CONTRACT CHANGE ORDER

CCO No. 5	Suppl. No.	Contract No. 78711	Road White Meadow Road and Peavine Ridge Road Storm Damage Repair	Federal Number(s) ELELC14
---------------------	------------	------------------------------	---	-------------------------------------

**PEAVINE RIDGE ROAD
 SLIDE REPAIR**

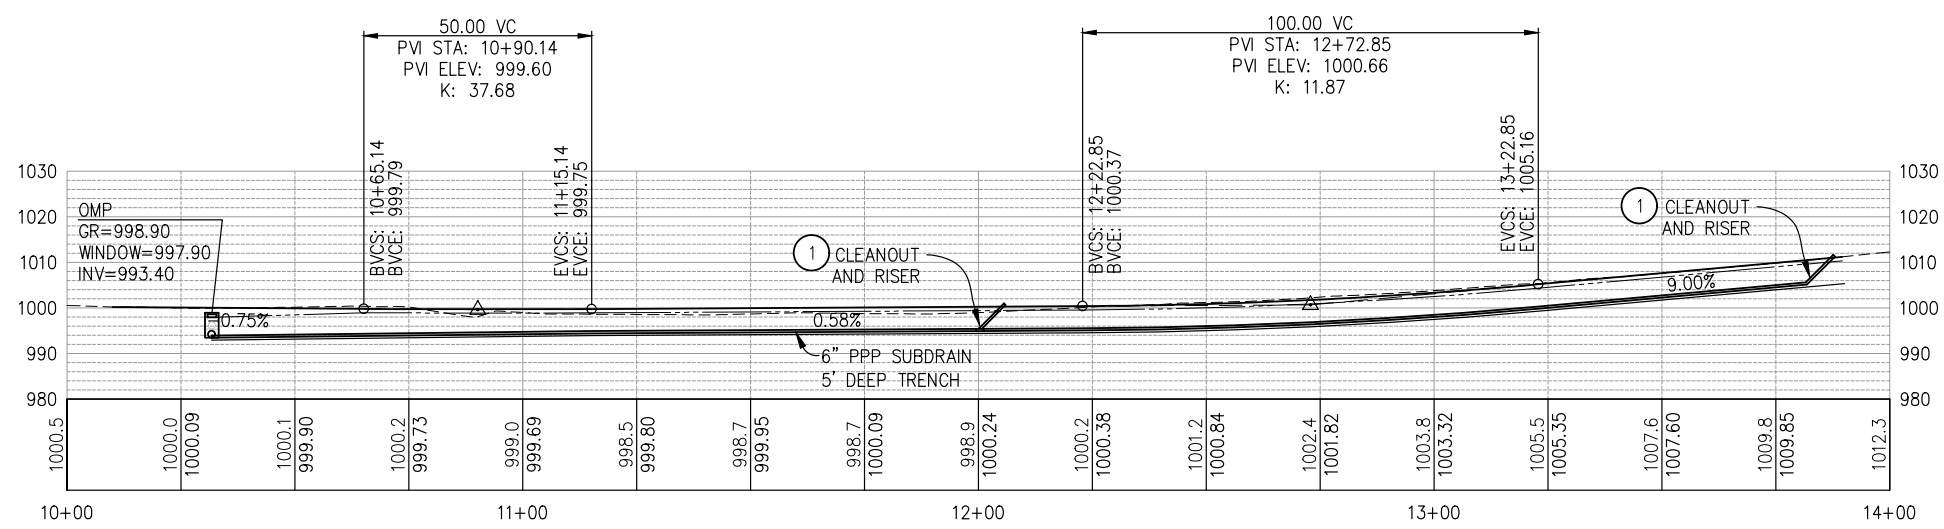
Approx.
location of
new ETW

Remove heaved
material. Will be left
in suitable condition on site.
(Location to be agreed upon.)

Clean up
slopes, re-apply
erosion controls.

SHEET
EX-3
 3 OF 3
 W.O. No. **78711**

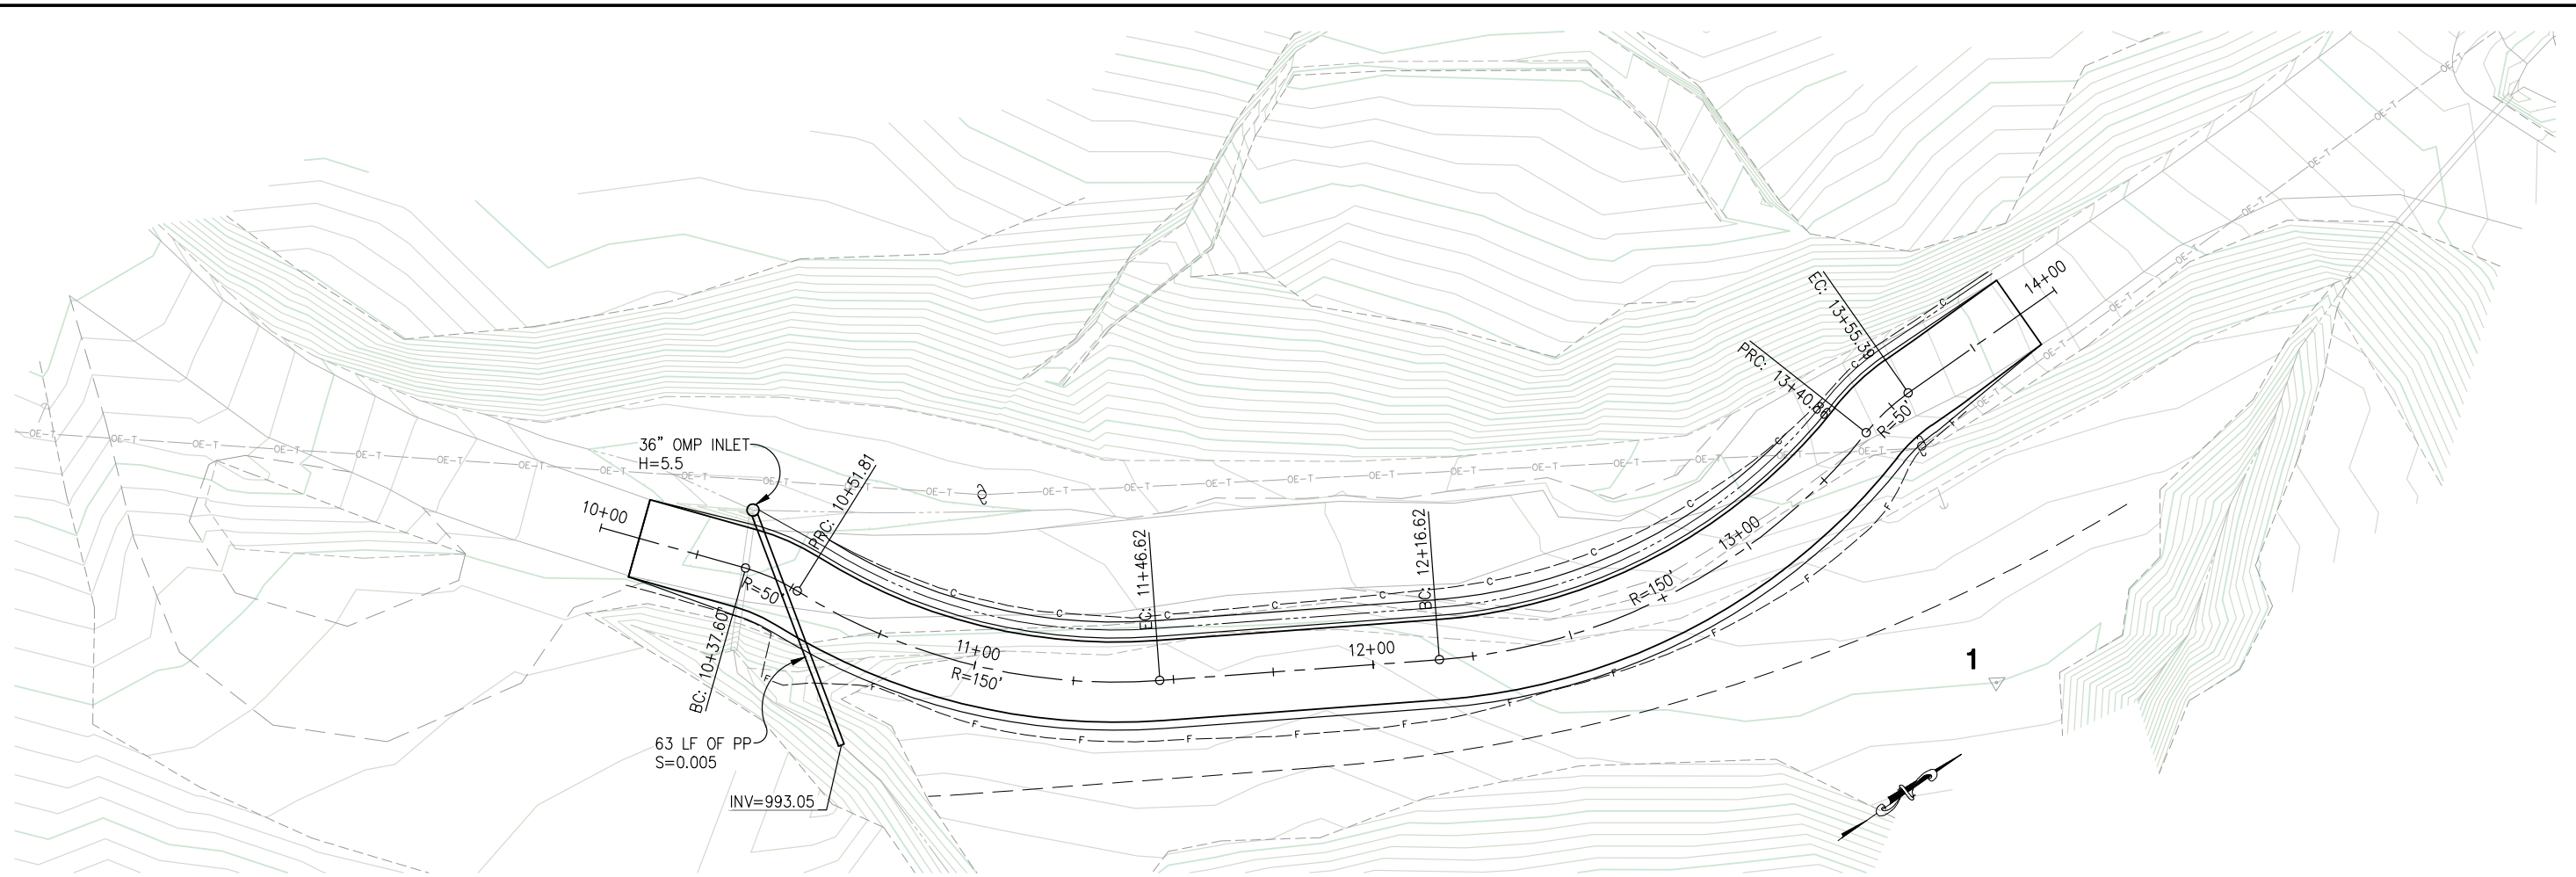
- As shown on Sheet 2 of this Contract Change Order,
 - Remove the heaved roadway material.
 - Remove the loose material present on and at the toe of slope. All of this material may be placed at locations within the project limits and as agreed upon by the County.
 - Remove and dispose of the damaged erosion control blanket. Hand broadcast native seed and place erosion control blanket on the slopes.
- As shown on Sheet 3 of this Contract Change Order, realign and re-construct approximately 300-feet of Peavine Ridge Road.

- CONSTRUCTION NOTES:**
- CUT=250 CY
 - FILL=105 CY
 - SECTION (3" HMA OVER 6" AB)
 - HMA=137 TONS
 - AB=140 CY
 - 360 LF 6" PPP SUBDRAIN (SMOOTH WALLED INTERIOR)
 - 1 EA OMP INLET
 - 63 LF 18" DRAIN PIPE
 - ① — CLEANOUTS, TOTAL OF (2), EXACT LOCATIONS TO BE DETERMINED BY THE ENGINEER
